Illinois Department of Transportation

SUBJECT: Aurora Municipal Airport
Aurora, Illinois
Kane County
Illinois Project Number: ARR-5201
SBG Project Number: 3-17-SBGP-TBD
Contract No. AU075
Item No. 06A, November 7, 2025 Letting
Addendum A

NOTICE TO PROSPECTIVE BIDDERS

REPLACE AIRFIELD
SIGNAGE, WIND CONES,
RUNWAY 15 AND 27
RUNWAY END
IDENTIFIER LIGHTS,
AND AIRPORT
ROTATING BEACON

WIND CONE FOUNDATION

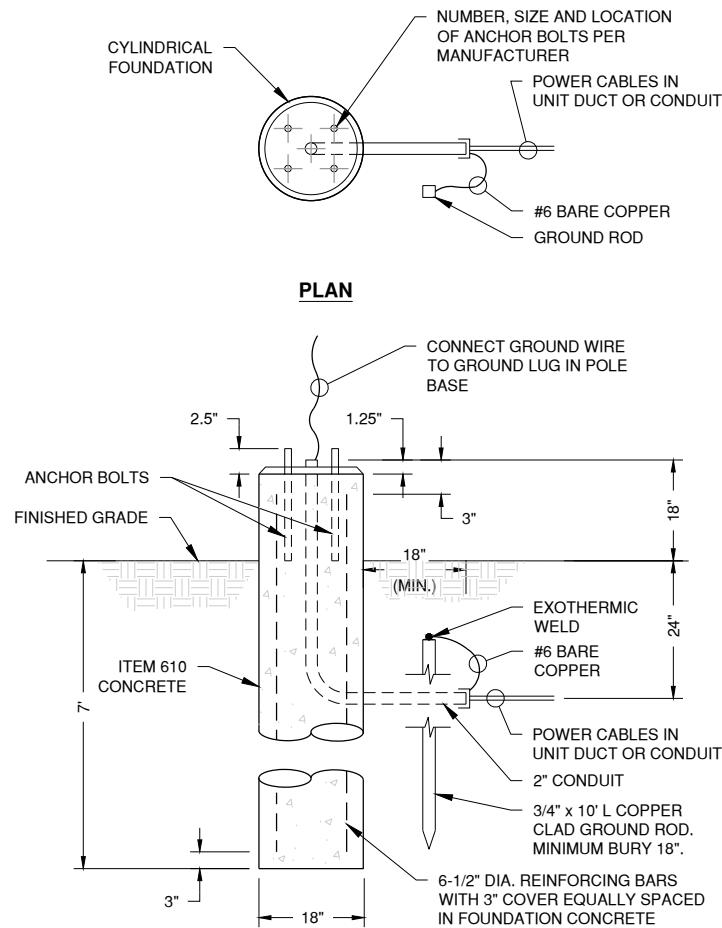
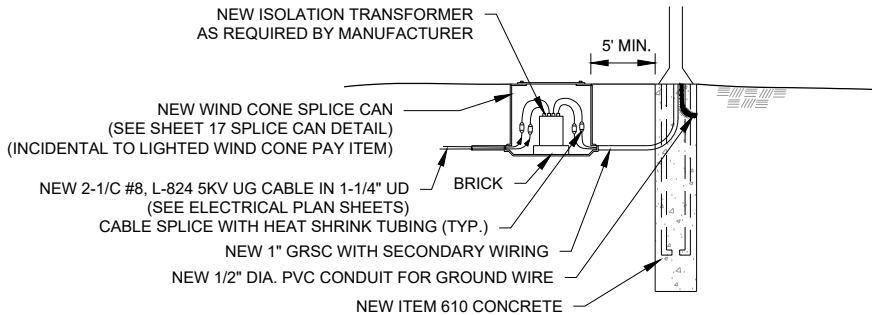
- a. Revise Electrical Note 1.
8. Sheet 20 – Electrical Details – 4
 - a. Add note to Detail 15.
 - b. Leave in Detail 14.
9. Sheet 23 - Electrical Details – 7

10/22/25 ADD NOTE TO DETAIL 15
LEAVE IN DETAIL 14

NOTE: THIS FOUNDATION DETAIL SHALL ALSO BE USED FOR L-907 WIND CONE RELOCATION.

ELECTRICAL
DETAILS - 7

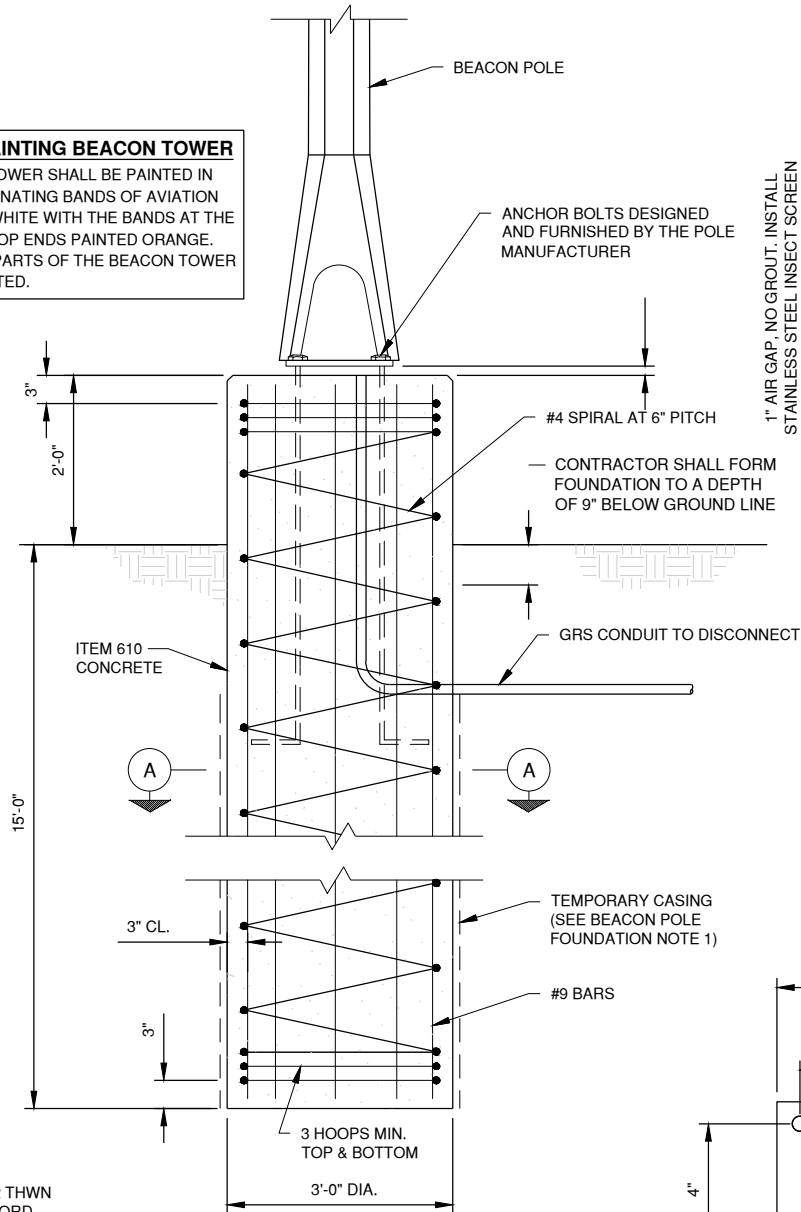
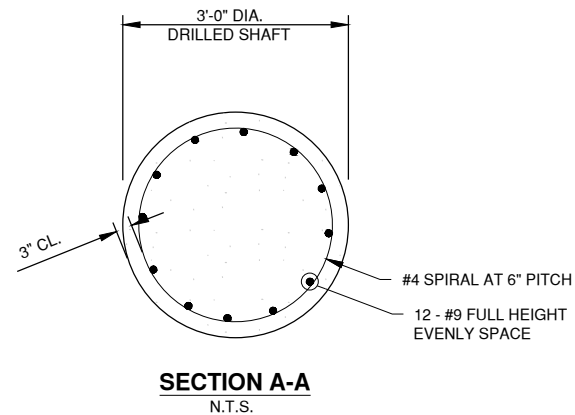
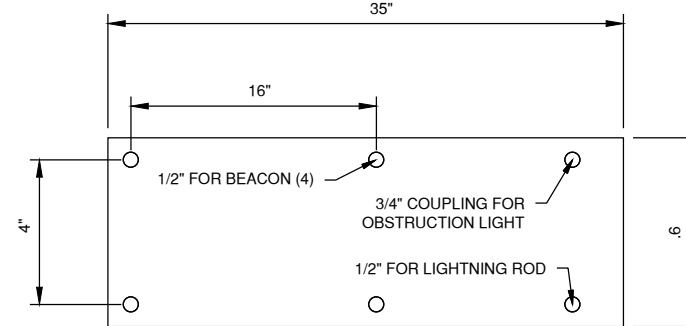
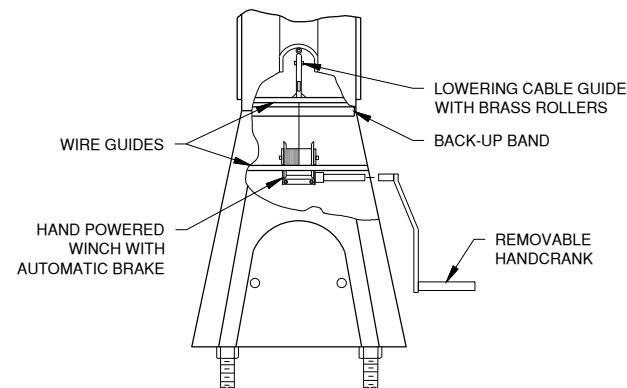
- a. Revise title for Detail 25.
 - b. Revise Detail 24.
10. Sheet 25 – Electrical Vault Details
 - a. Revise Vault Nomenclature Note 34.
 - b. Revise Vault Nomenclature Note 38.

10/22/25 REVISE TITLE FOR DETAIL 25
REVISE DETAIL 24

ELECTRICAL VAULT DETAILS

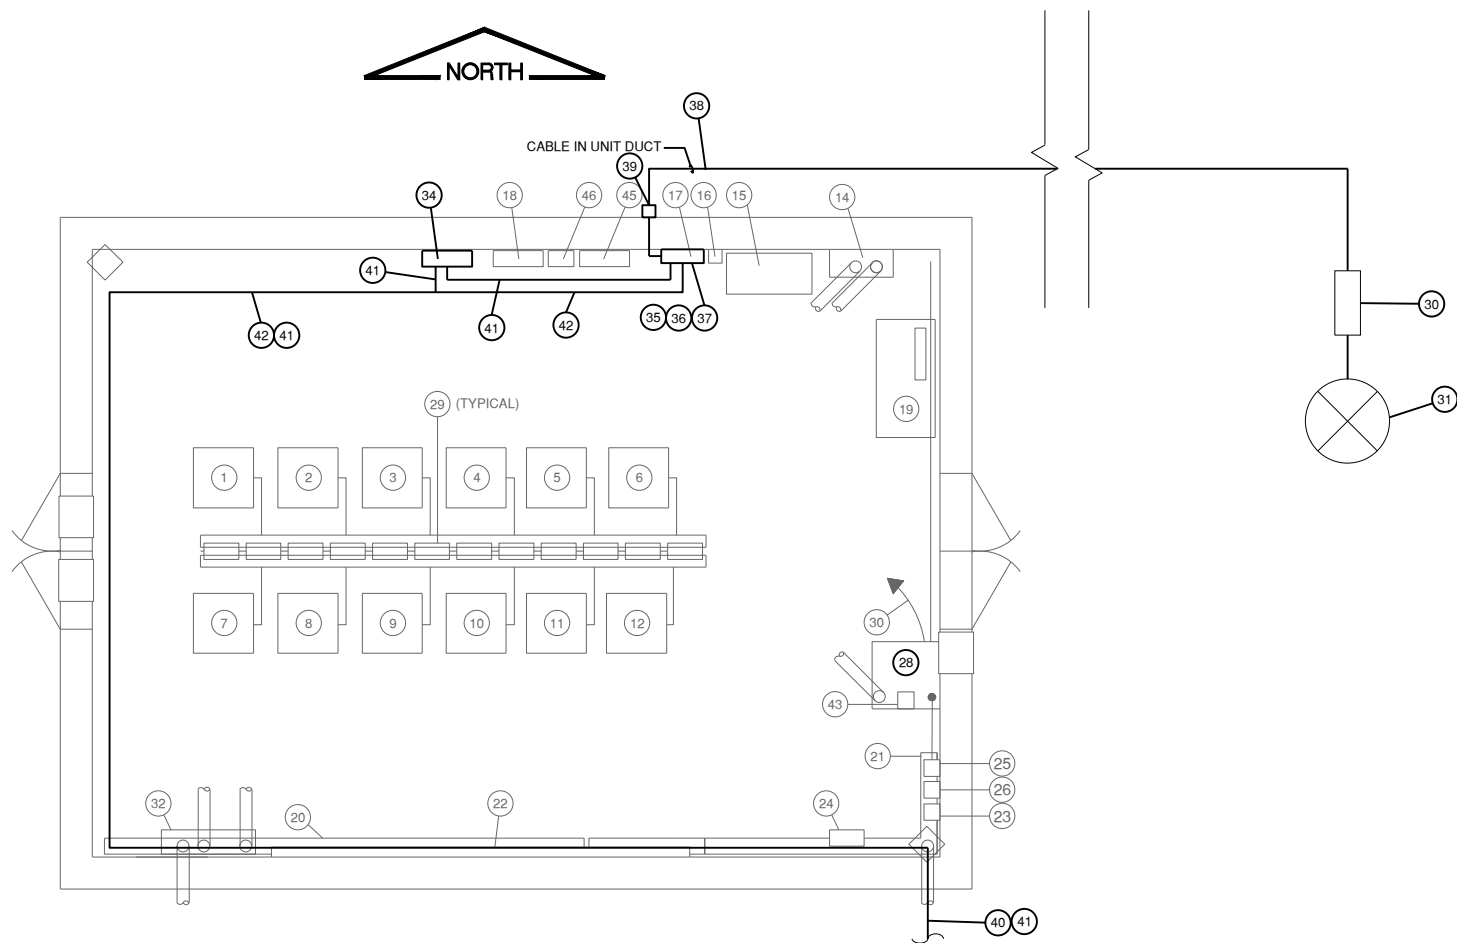
c. Add Note 3.

10/22/25	REVISE VAULT NOMENCLATURE NOTE 34 REVISE VAULT NOMENCLATURE NOTE 38 ADD NOTE 3
MARK	DATE	DESCRIPTION

1. EXISTING EQUIPMENT TO REMAIN IS SHOWN FOR INFORMATION ONLY. NEW WORK IS SHOWN IN BOLD.
2. INSTALL LAMACOID NAMEPLATES ON ALL EQUIPMENT.
3. CONTRACTOR SHALL DRILL THROUGH EXISTING VAULT BUILDING FOR NEW CIRCUIT AND SEAL CONDUIT AROUND NEW ENTRANCE AT NO ADDITIONAL COST.

| 34. | NEW LIGHTING CONTACTOR FOR RGL CIRCUIT WITH HOA SELECTOR SWITCH. △ |
| 38. | NEW 2#10 XLP-USE, 1#10 GND IN 1" PVC SCH. 80 CONDUIT FOR BEACON. △ |
